Product Change Notification

112155 - 00

Change Notification #:	**112155 - 00**
Change Title:	**Intel® Ethernet Server Adapter X520-DA1 (Spring Fountain) SKU E10G41BTDAPG1P5 MM#927066** **PCN 112155-00** **Product Design, Product Material & Label** **Silicon Change, Update heatsink and Product Name Change**
Date of Publication:	**April 29, 2013**

New Heatsink	Old Heatsink

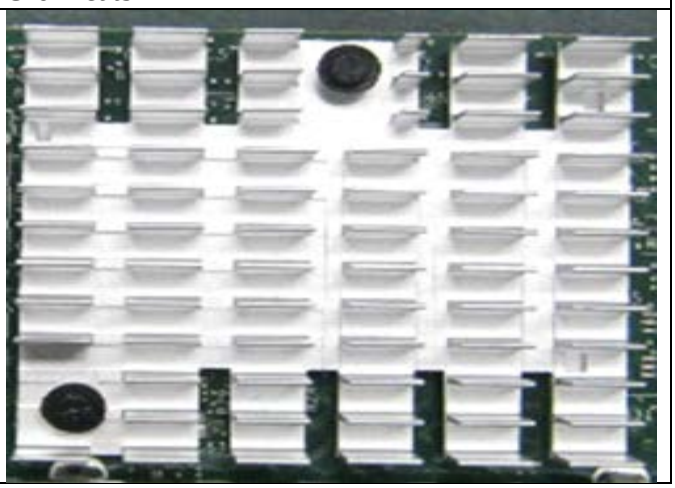
2. Updates have been made to the heat sink for the X520 adapters to allow for easier manufacturing of the heat sink part. The new heat sink is form, fit, function compatible and has been fully tested and qualified by Intel. Please see pictures below showing the visual difference of the old/new heat sink.
